# Rezoning Transportation Analysis

Petition Number: 2019-180

Date	Description
01-14-2020	First Review
02-11-2020	Second Review
08-25-2020	Third Review (LJensen)

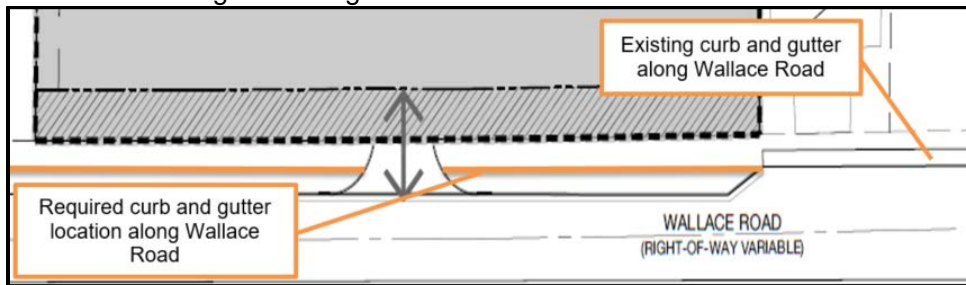
1. **Curblines:** The proposed zoning district has a setback measured from back of the existing or proposed future curbline.
  - a. ~~Wallace Road:~~ The proposed back of curb is 25.5' from the centerline of Wallace Road including half the 12' median, 11' travel lane, 6' bike lane, 2.5' curb and gutter, 14' planting strip, and 6' sidewalk.
  - b. ~~Pineborough Road:~~ The cross section the petitioner has provided, 58' from back of sidewalk to back of sidewalk, is sufficient.

The site plan should show the curb and gutter labeled and dimensioned from the centerline for each road.

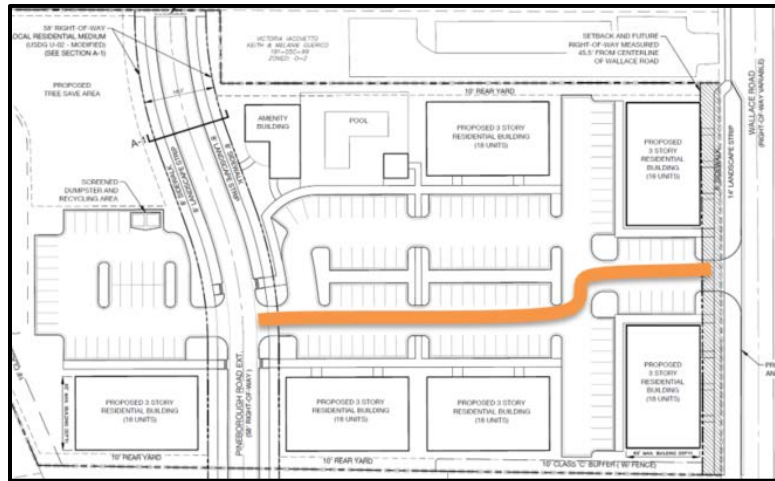
4. ~~In accordance to the council adopted Urban Street Design Guidelines, the petitioner should revise the site plan and conditional note(s) to commit to construct a public street to connect Pineborough Road extension and Wallace Road. The cross section should include an 8-foot planting strip, and 8-foot sidewalk due to the proposed density of 22 DUA to comply with Chapter 20 Subdivision ordinance.~~
  - a. ~~Technical Correction (02-10-2020)~~ The site plan should commit to constructing a private street connection between Pineborough Road to Wallace Road to improve street connectivity, similar to what was done for rezoning petition 2019-074.
